**CONTRACT: N.003-010-2017/2  
PARADISE VALLEY VIADUCT****Minutes of Meeting to Discuss Environmental Matters Relating to  
the Paradise Valley Viaduct on the N3 over the Paradise Valley  
Nature Reserve**

Held on Monday, 18 June 2018 at Paradise Valley Nature Reserve Hall

#### EXISTING AND PROPOSED PIERS

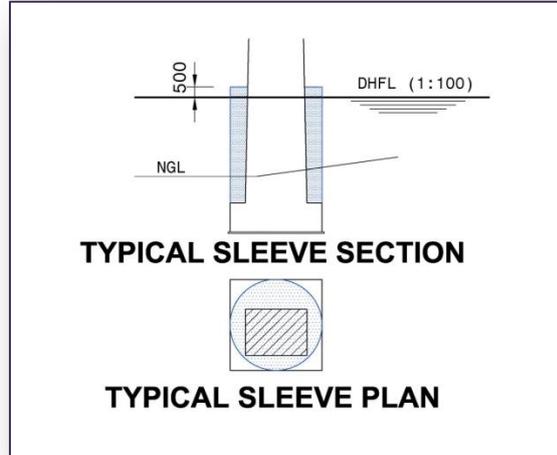
- **Existing Piers**  
Consist of 2 Rectangular Hollow Box Piers with Trestle Beam to Support Super Structure. Pier height 35,5m.
- **Proposed Piers**  
Consist of an Additional 2 Rectangular Hollow Box Piers with New Trestle Beams to Support the New Super Structure.

- **Two Shapes of Piers were Investigated**
  - Rectangular to match existing
  - Rectangular to match existing with Round Jackets up to Flood level for the 5 piers in the water.

- **Hydraulic Considerations**
  - It was thought that the flow around circular piers would be more efficient and reduce debris build up.
  - Hydraulic calculations indicate that the Round Piers in fact dam up the water to a greater extent than the rectangular piers.

- For a 1:100 year flood as indicated the:
    - DHFL without Piers = 248,78
    - DHFL with Rectangular Piers = 249,02
    - DHFL with Round Piers = 249,31

- The Rectangular Piers are approximately 45° to the flow and provide a cut water to the flow and have the smallest effect on the flow. Relative to the flow of water the piers have a diamond shape.

- We recommend that the circular columns are not constructed as they will not improve the flow regime under the Bridge. For Debris Control we recommend that a Debris Trap is constructed upstream as described above.

3.6.2	<p><b>PREFERRED SHAPE – RECTANGULAR</b></p> <p>The following was agreed to in the meeting:</p> <ul style="list-style-type: none"> <li>• Observed flood levels correspond well with the calculated flood levels.</li> <li>• <b>The square (diamond shaped) pier was accepted by the meeting as the optimal shape.</b></li> <li>• Concern about debris build up between piers rather than on a single pier. Effect of this to be investigated and reported on.</li> <li>• Increasing the depth of channel was rejected as it would require blasting. Suggested that possibly the western side of the channel be opened up to increase the stream bed width. This area is previously disturbed (clay). Existing foot paths will have to be realigned. SANRAL agreed that this could be done under their contract.</li> <li>• eThekweni requested that the impact of smaller floods (1 in 5 year, 1 in 10 year and 1 in 20 year) be investigated as well related to the possible channelization.</li> <li>• It was noted that flood events are becoming more frequent, as a result of the development of West Meade industrial area, located upstream.</li> <li>• The construction of an upstream debris trap was not accepted by eThekweni.</li> </ul>	<p>SNA</p> <p>SNA</p> <p>SNA</p>
